CITY OF ALBUQUERQUE

Re: Christmans Apartments
2040 Willis Pl., SW
Traffic Circulation Layout
Engineer's/Architect's Stamp 3-8-16 (J13-D202)

Based upon the information provided in your submittal received 3-10-16, the above referenced plan cannot be approved for Building Permit until the following comments are addressed:

Figure 1. Mini Clear Sight Triangle

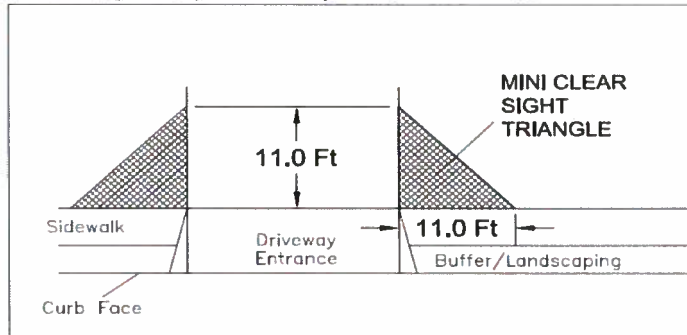
11. Please add the following note to the clear sight triangle: "Landscaping and signage will not interfere with clear sight requirements. Therefore, signs, walls, trees, and shrubbery between 3 and 8 feet tall (as measured from the gutter pan) will not be acceptable in this area."
12. Unused curb cuts must be replaced with sidewalk and curb & gutter. A build note must be provided referring to the appropriate City Standard drawing.
13. All broken or cracked sidewalk must be replaced with sidewalk and curb & gutter. A build note must be provided referring to the appropriate City Standard drawing.
14. Please include a copy of your shared access agreement with the adjacent property owner.
15. Please include two copies of the traffic circulation layout at the next submittal.

SHEET NUMBER
C-1.0

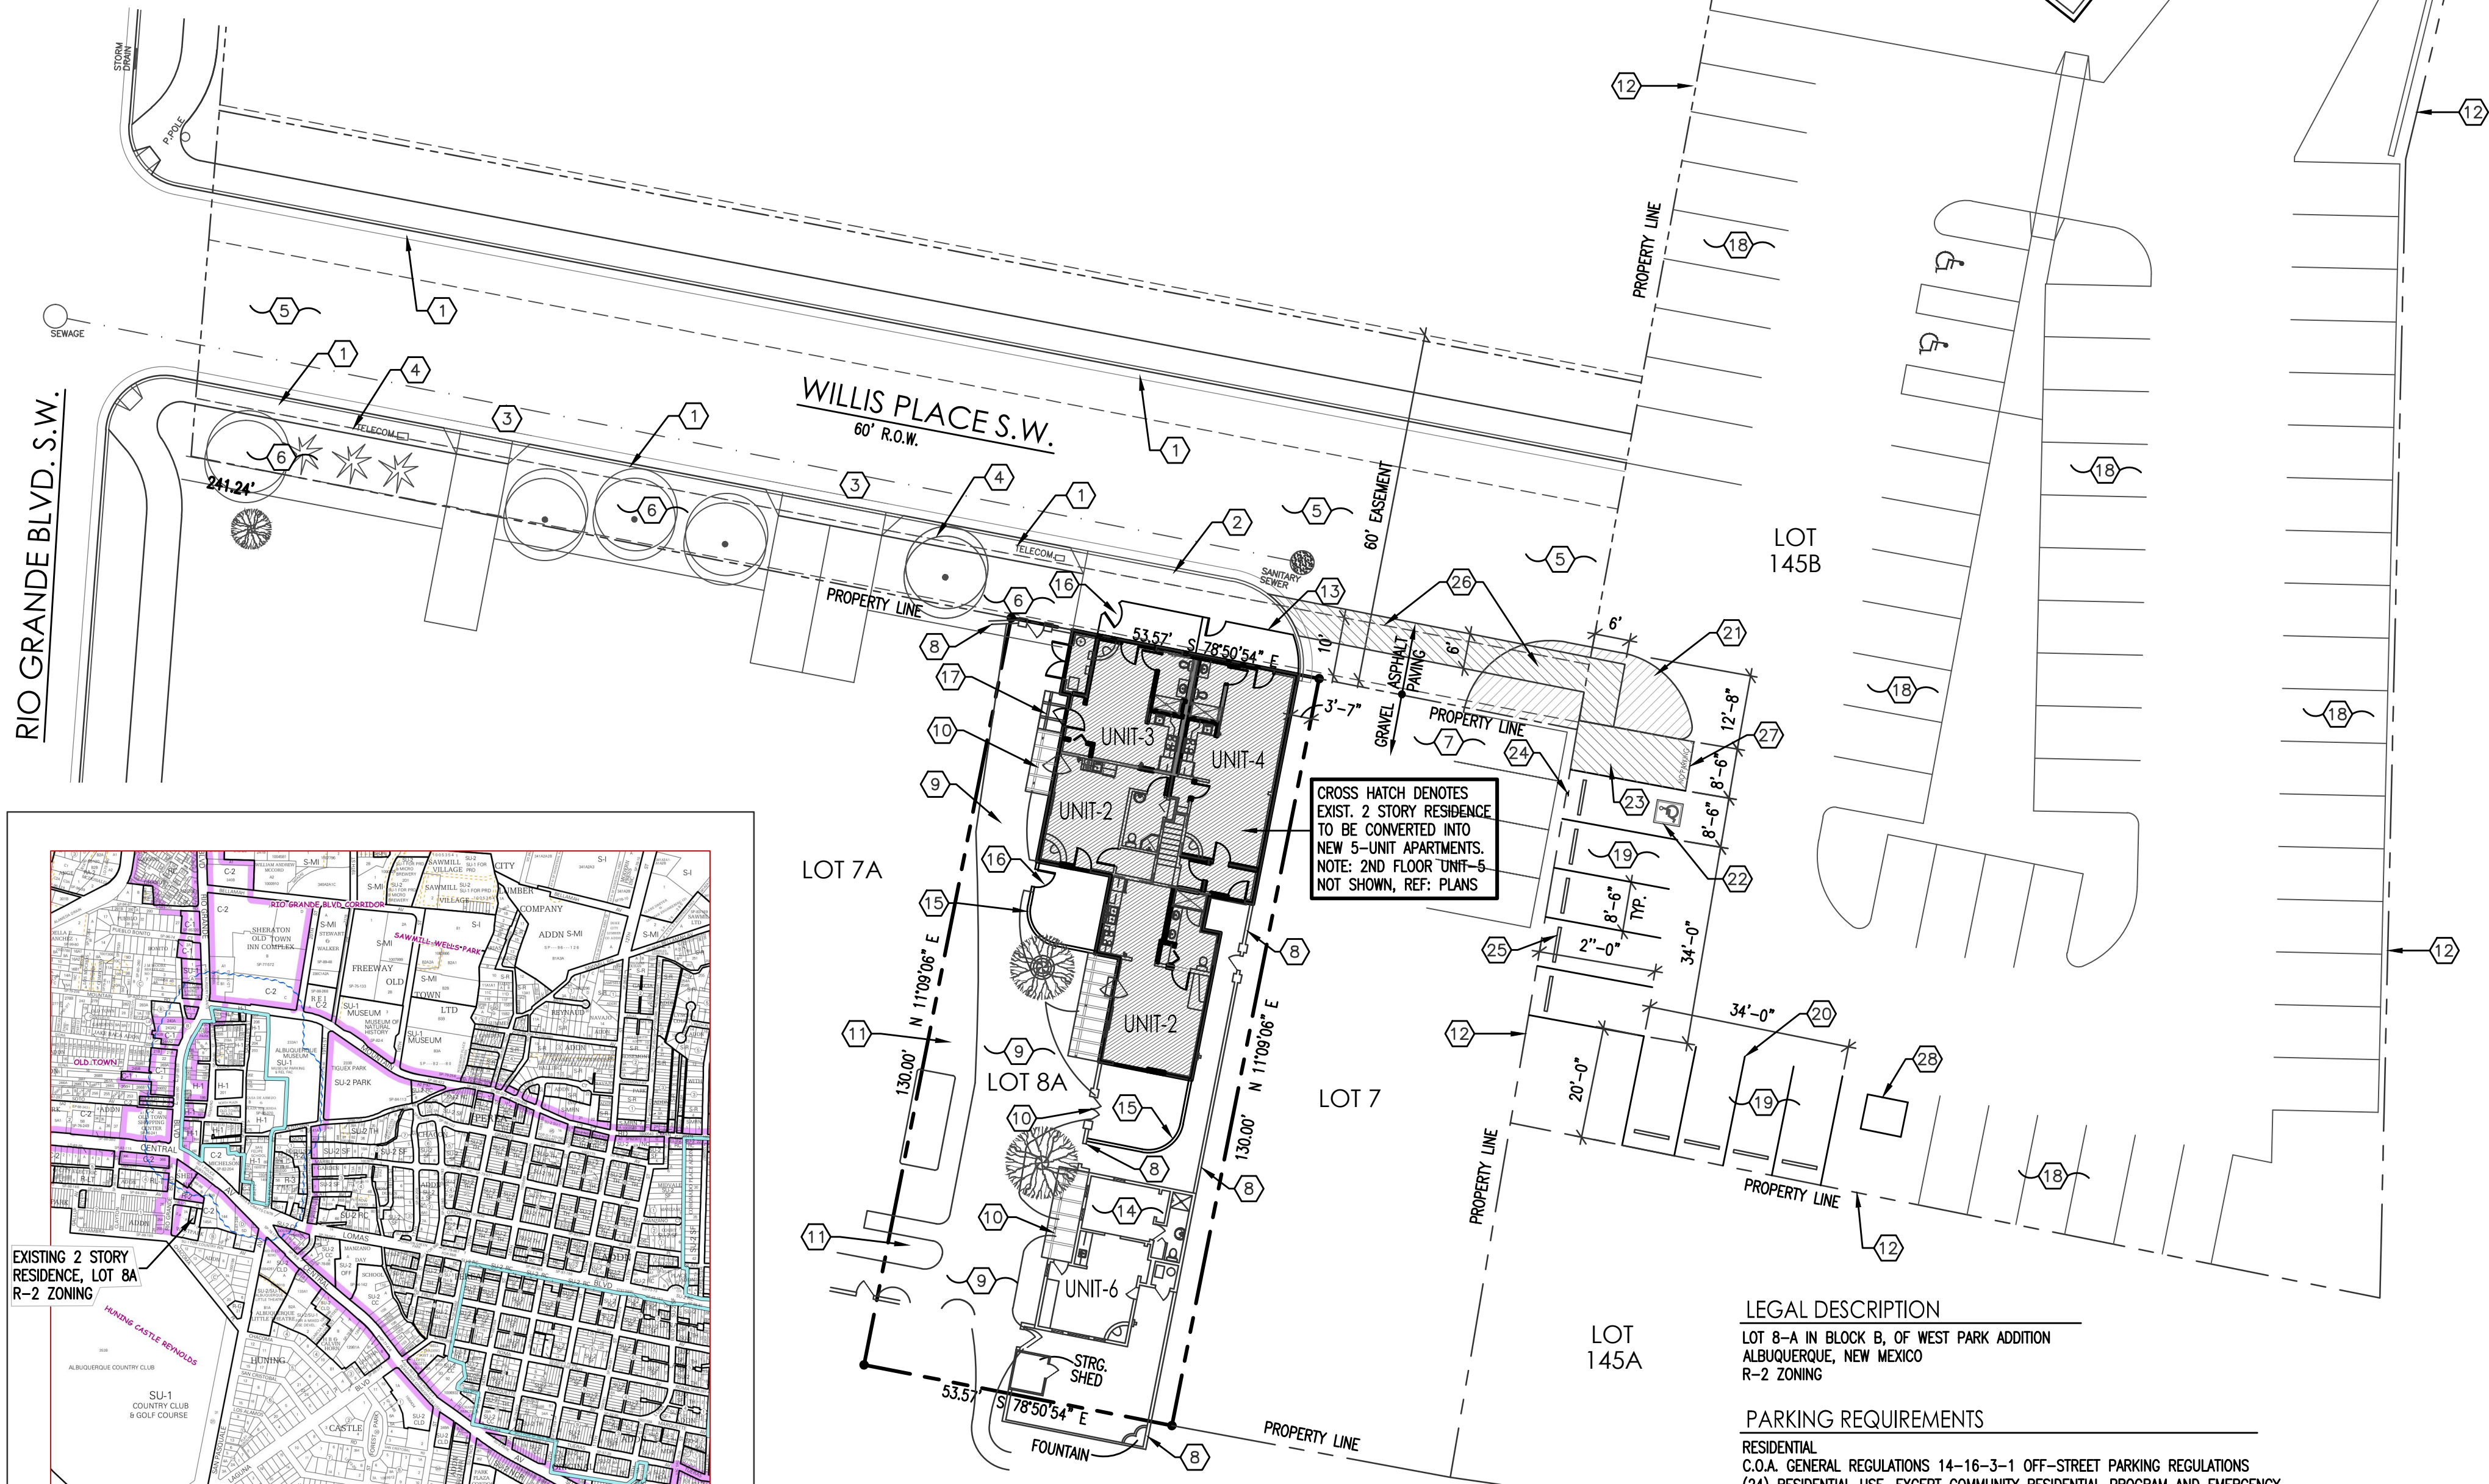
1. Please detail and dimension all existing sidewalks, curb cuts and drive pads.
2. Grades and slopes on the handicap accessible pathway appear to be too large. Please provide more detail.

3. Please list the width and length for all existing and proposed parking spaces. In review of the submitted drawing, there seems to be a mistyped parking length for the parking spaces to the east of the project site.

4. Show all drive aisle widths and radii.
5. Per DPM, a 6 ft. wide ADA accessible pedestrian pathway is required from the public sidewalk to the building entrances. Please clearly show this pathway and provide details of sidewalk dimension and slope.

6. Per DPM, a 6 ft. wide ADA accessible pedestrian pathway is required from the HC parking stall access aisles to the building entrances. Please clearly show this pathway and provide details. The ADA pathway must be a solid surface and have appropriate striping. Roll curb is not permissible for ADA pathway.

7. A Revocable Permit will be required for the fencing and any patio in the ROW.
8. Please state if the garage entrances are still in place and being used or if they have been renovated and removed from the apartment structure.

9. Service vehicle and/or refuse vehicle maneuvering must be contained on-site; provide a copy of refuse approval.
10. Please provide a sight distance exhibit (see the *Development Process Manual, Chapter 23, Section 3, Mini Clear Sight Triangle*). Please provide this detail for entrance/exit on Willis Place.
